GENERAL NOTES
2018 TID NO. 1 INFRASTRUCTURE
TRAIL IMPROVEMENTS
GAYS MILLS, WISCONSIN

PLAN & PROFILE
2018 TID NO. 1 INFRASTRUCTURE
TRAIL IMPROVEMENTS
GAYS MILLS, WISCONSIN

SCALE	AS SHOWN
DATE	JULY 2018
DRAFTER	PJUN
CHECKED	MMUC
PROJECT NO.	180089
SHEET	15 OF 24
DWG. NO.

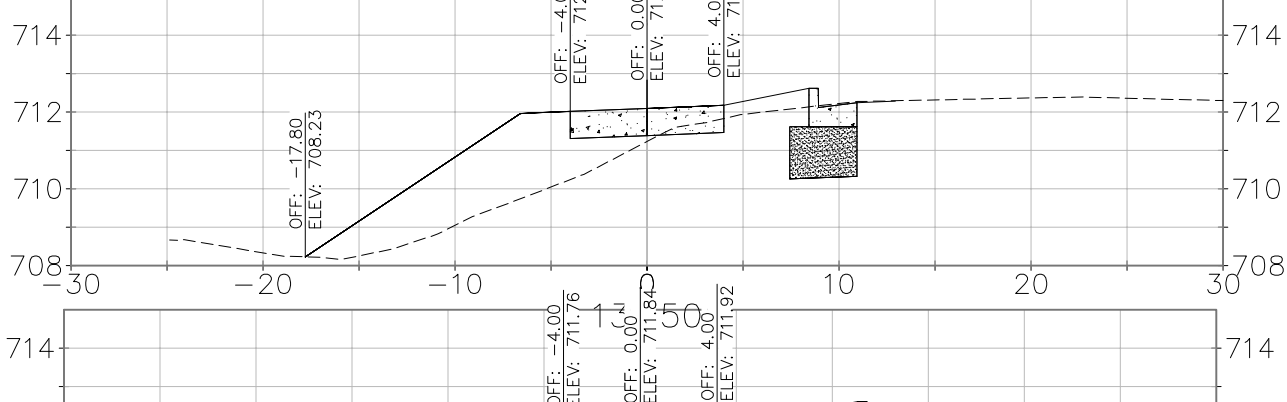
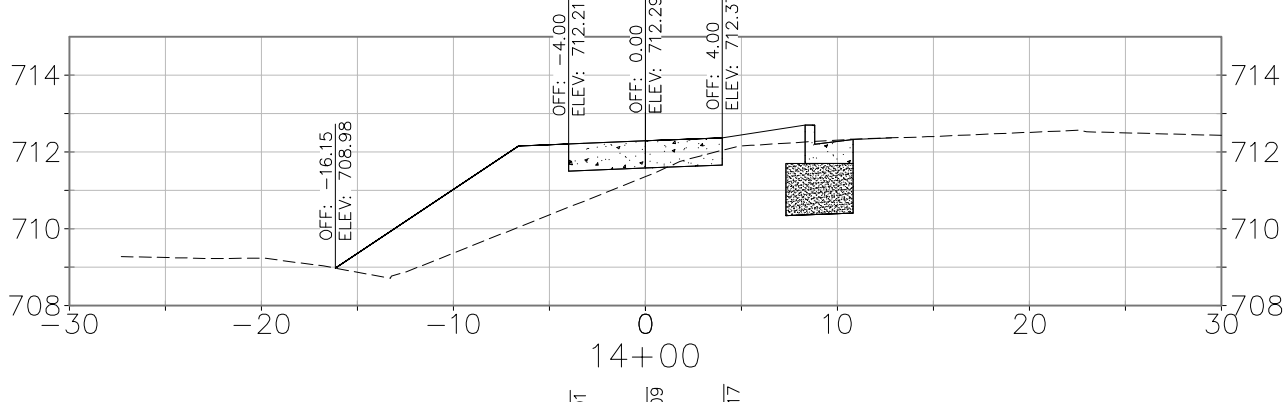
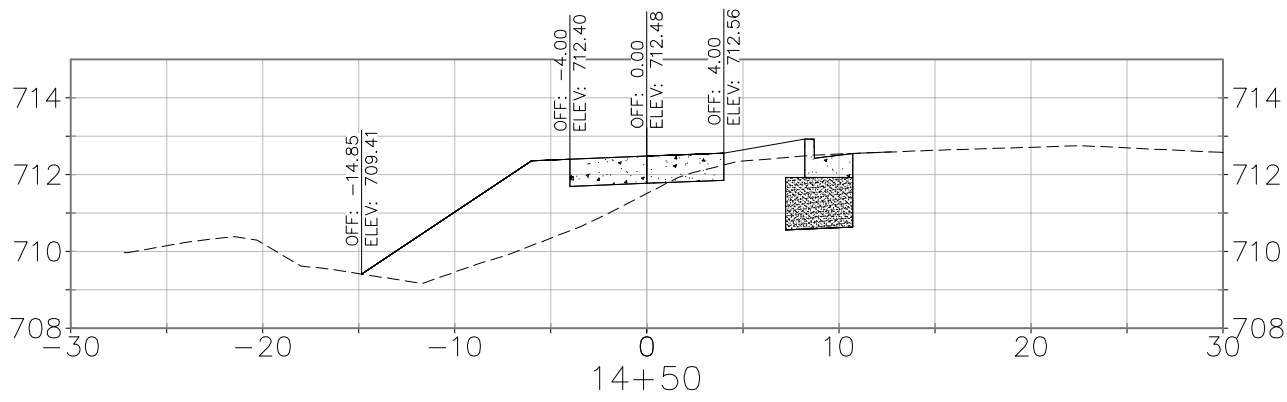
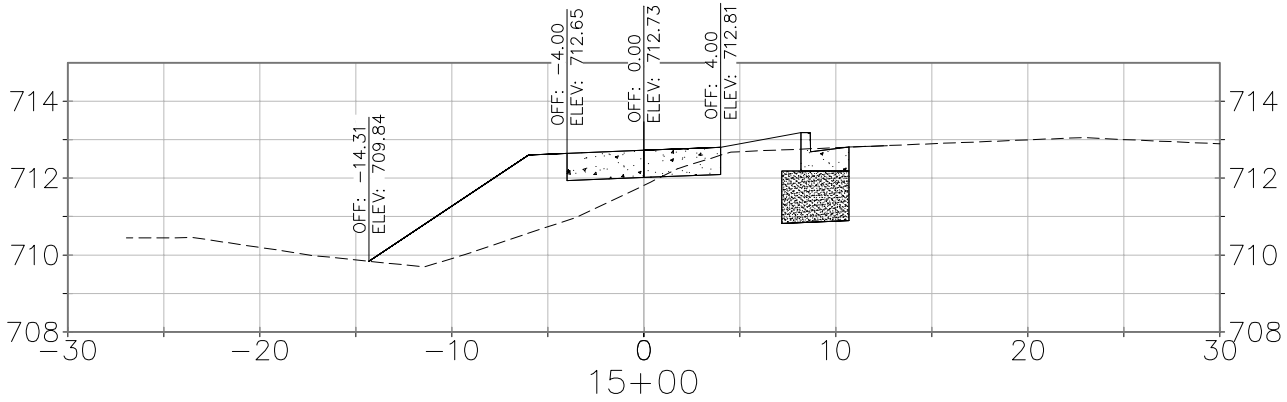
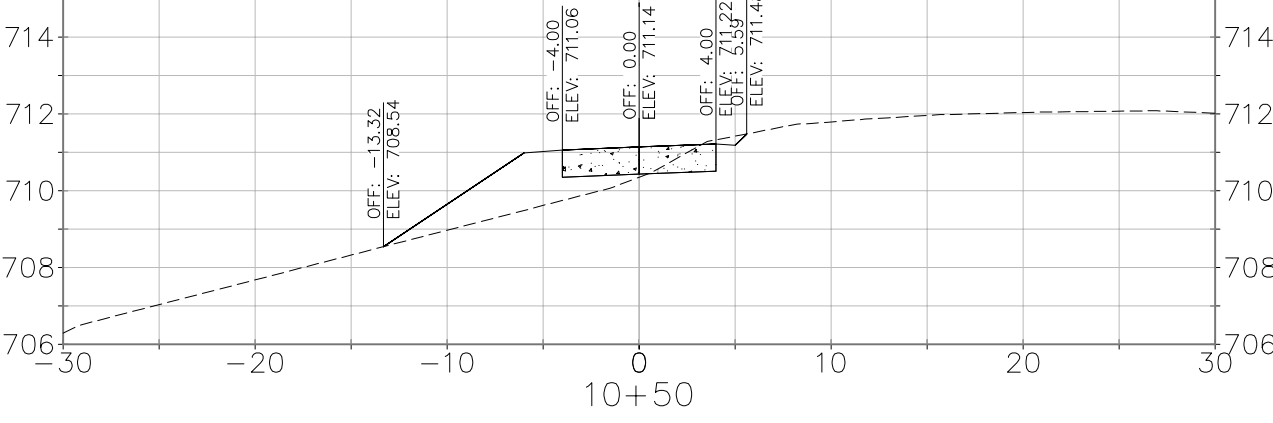
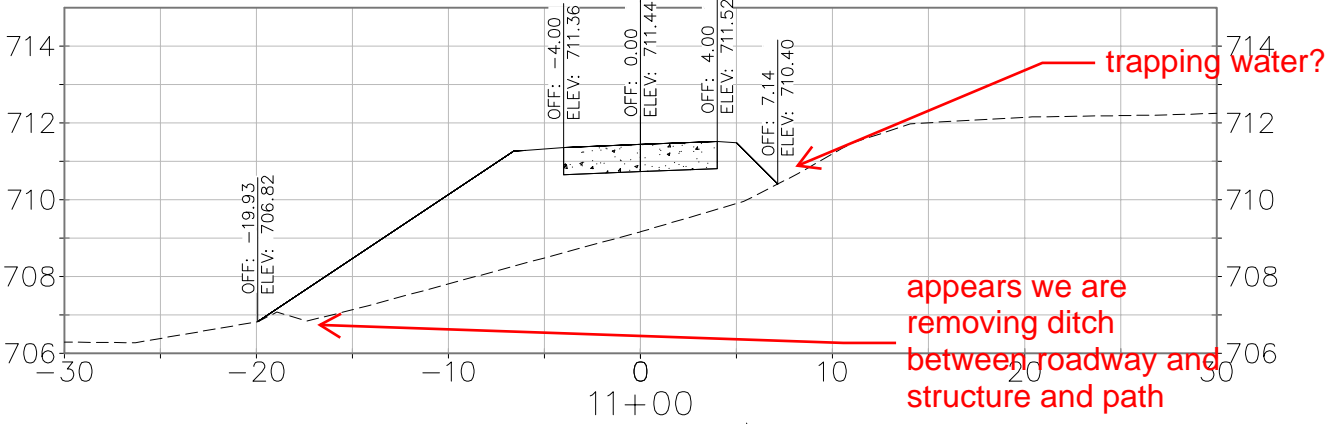
NEED CROSS SECTIONS TO INCLUDE:
right of way lines and utilities

SDD 15c4 Traffic Control, Advance Warning Signs 45 M.P.H. or Greater, Two Way Undivided Road Open to Traffic

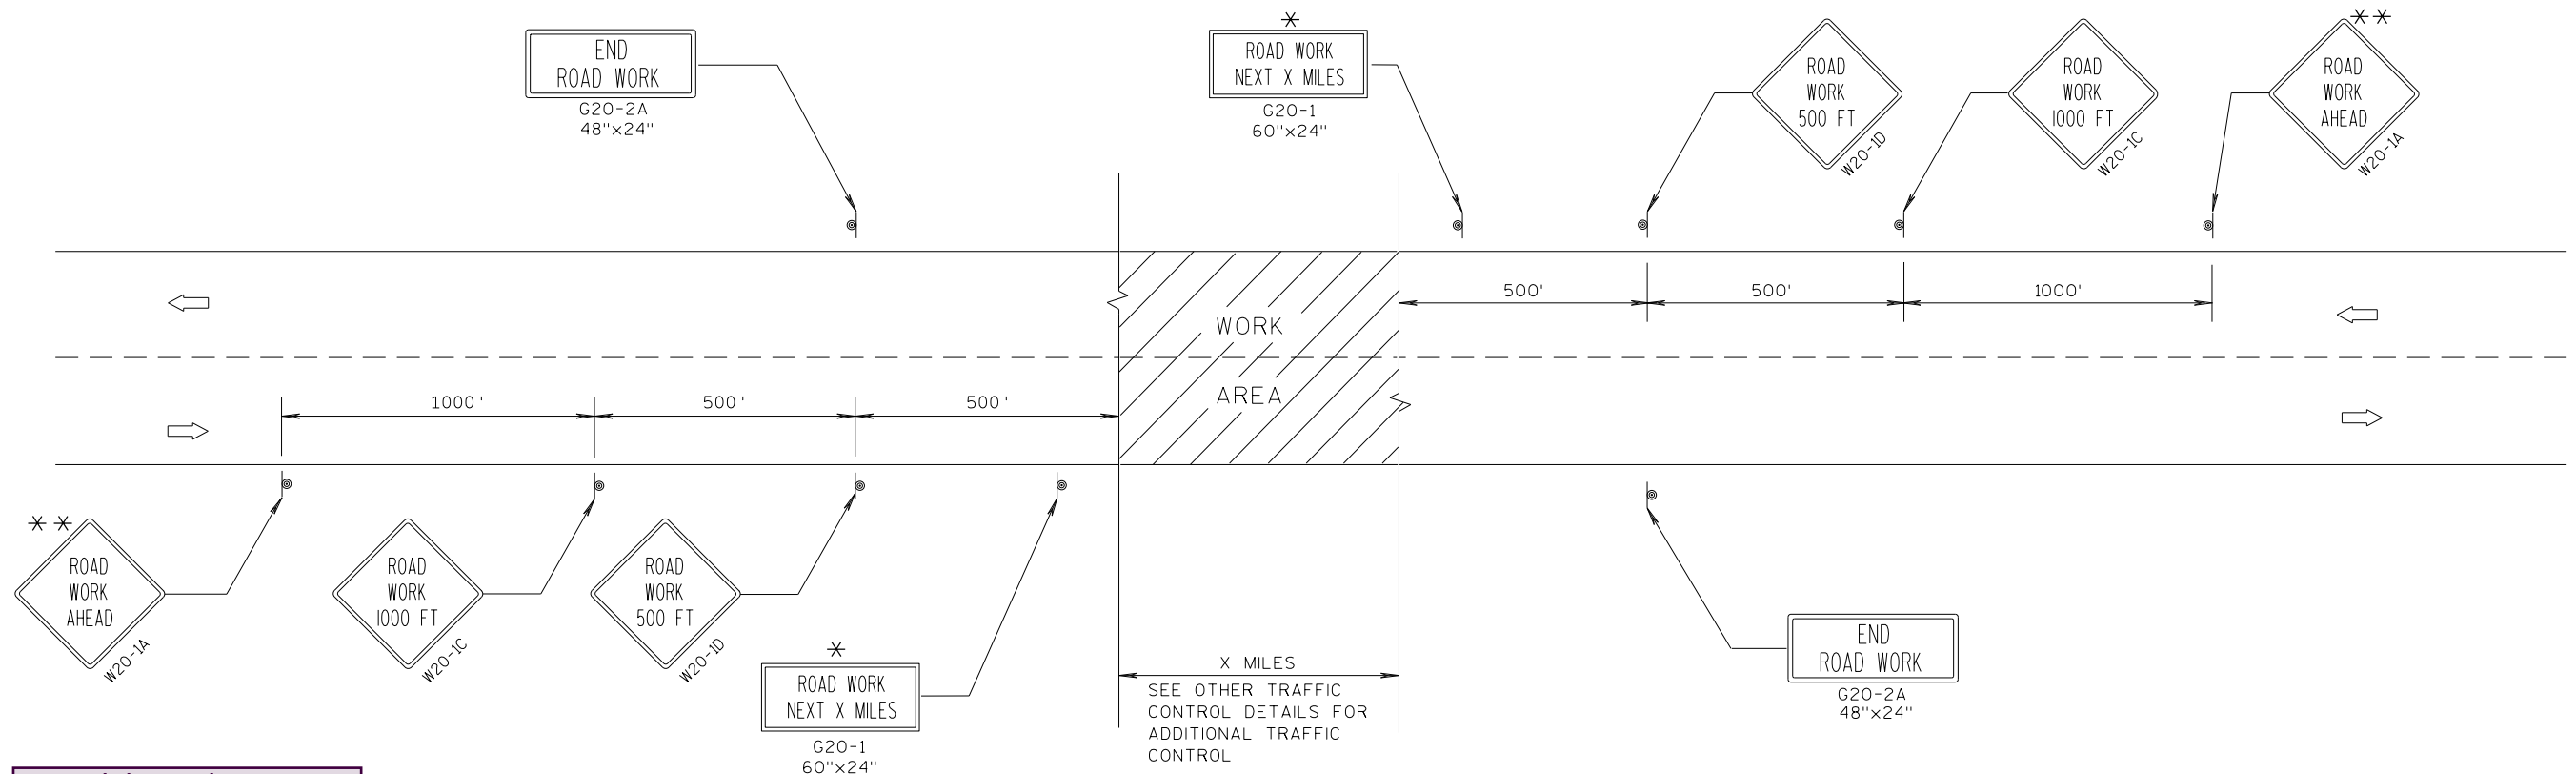
at a minimum lay your signs out to see where they land, NB traffic may have sight distance issues due to the hill.

TRAFFIC CONTROL FOR LANE CLOSURE WITH FLAGGING OPERATION

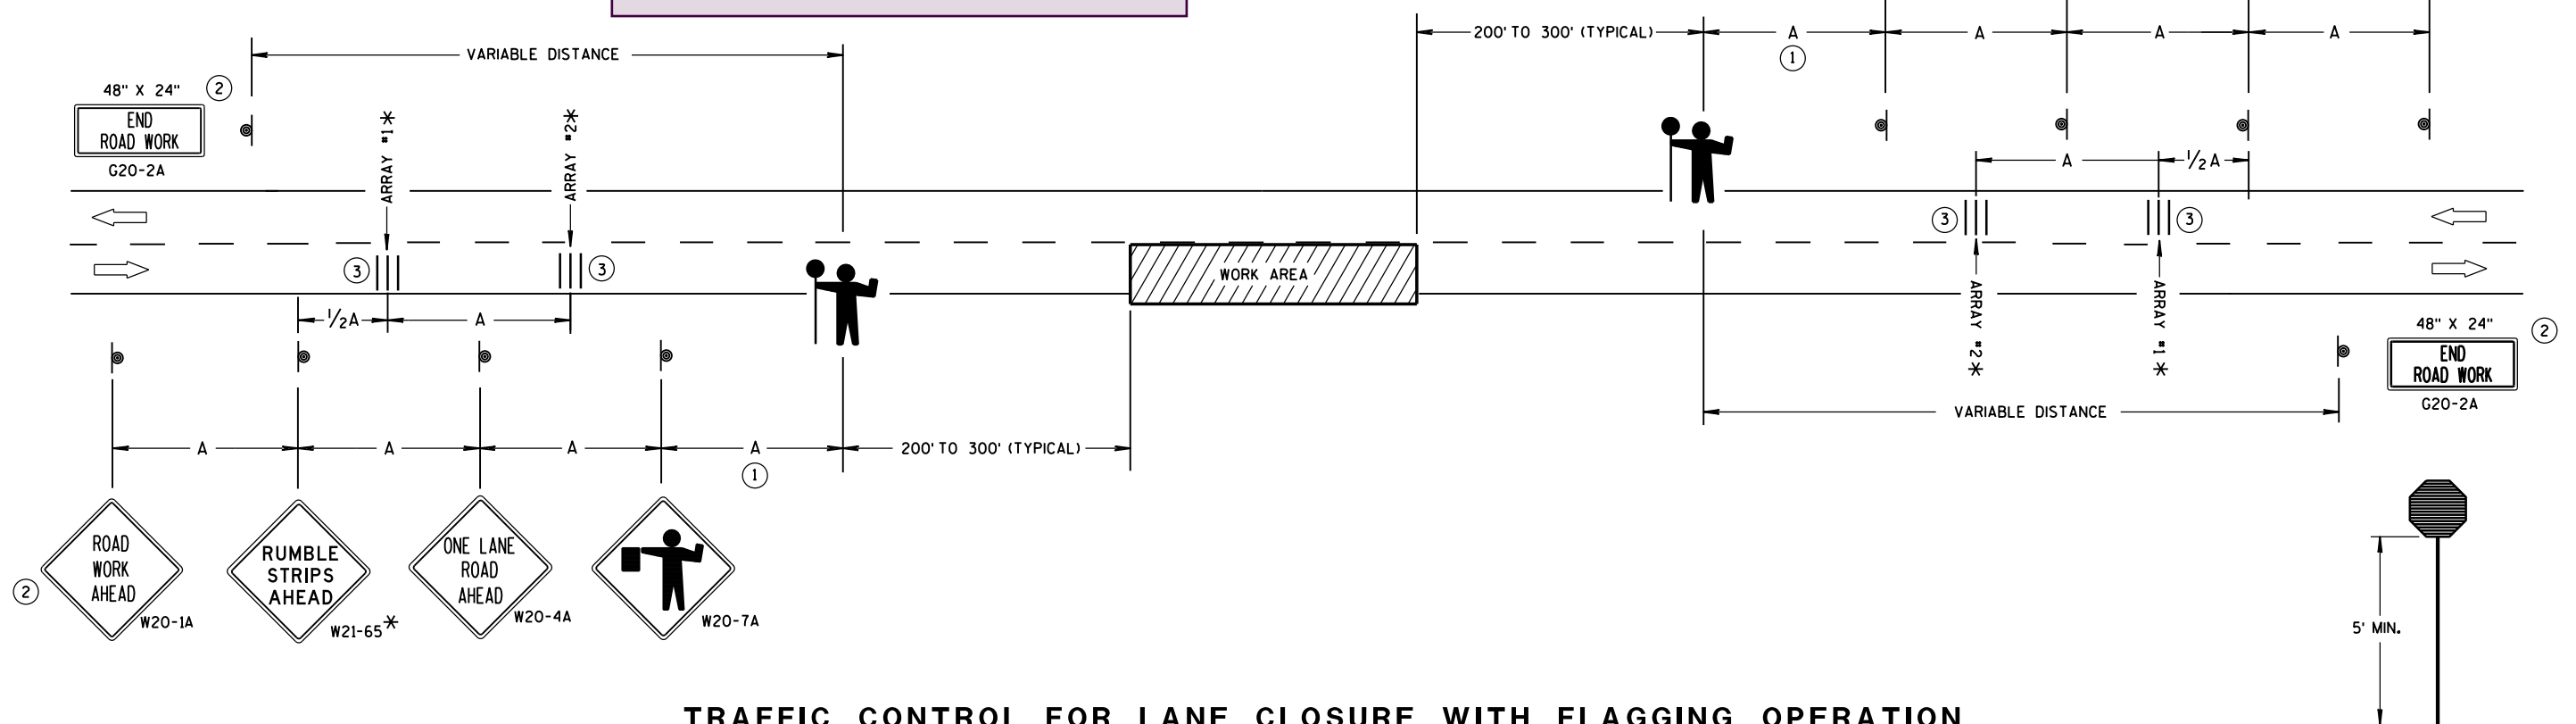
Not the most current SDD - only one TPRS is required.

Not sure a SDD is appropriate for this area due to turn lanes and islands. I would show out a TC plan sheet or two.
